INITIAL FIRE SAFETY INSPECTION REPORT

KSI Karnaphuli Shoes Industries Ltd.(Garments) (Extension)

RSC ID: 24604

Fire Safety Inspection Report

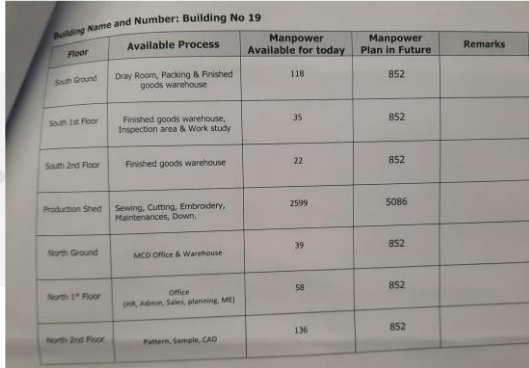
F-05	Fire Rated Construction	Elevator shafts are directly open into the production floor and exit stair enclosure without proper fire separation.	An exit stairway shall not be built around a lift shaft unless both of them are located in a smoke proof enclosure and made of a material with fire resistance rating required for the type of construction of smoke proof enclosure. Ensure minimum 2-hr listed/ approved 3rd part certified fire rated lift landing doors for elevator shafts.	Within 3 months

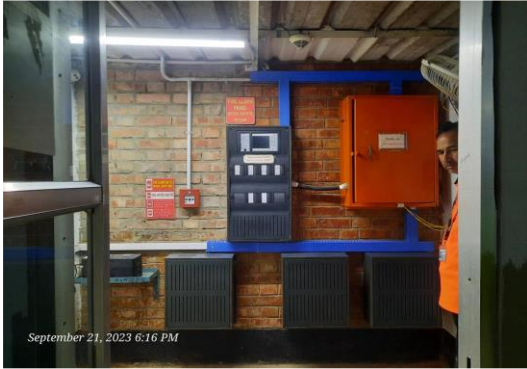
F-02	Fire Rated Construction	Penetrations through floor/ceiling assemblies are found unsealed. Location: Electric Cable and PVC pipe.	Seal all penetrations in floor/ceiling assemblies by a listed through-penetration fire stop system tested in accordance with ASTM E814 or approved alternative standard to maintain minimum 3-hr. fire resistance rating. Installation shall be as per manufacturer published installation guideline and the certification authority guideline to ensure the fire-rating. or, Provide a minimum 2-hr fire rated shaft to separate the utility risers from each floor if required.	Within 3 months
ADD PHOTO  PHOTO

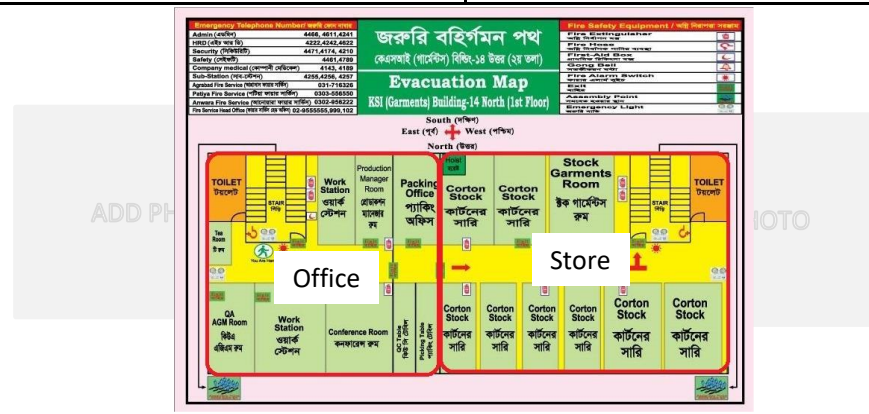
SI No.	Category	Findings	Required Action	Remediation Time Frame
F-01	Fire Rated Construction	The production Shed (interim structure) is made of steel and found exposed without any fire protection which is defined as non-rated construction and a violation of BNBC-2006.	Construction must be of type 1 or type 2 (See BNBC 2006 Part 3 Section 3.2.4, page 10356). For type 2 construction, the maximum permissible height of the building shall be 4 storeys or 14 meters. (See BNBC 2006 Part 3, Table 3.1.9, page 10319). Provide/ensure required fire rating on the structural elements by following Section 4.4 and Table 4.4.1 of the RSC Standard and RSC TECHNICAL GUIDANCE (TGN). Consult a qualified fire protection engineer to design the rated construction barriers.	Within 6 months
ADD PHOTO  ADD PHOTO
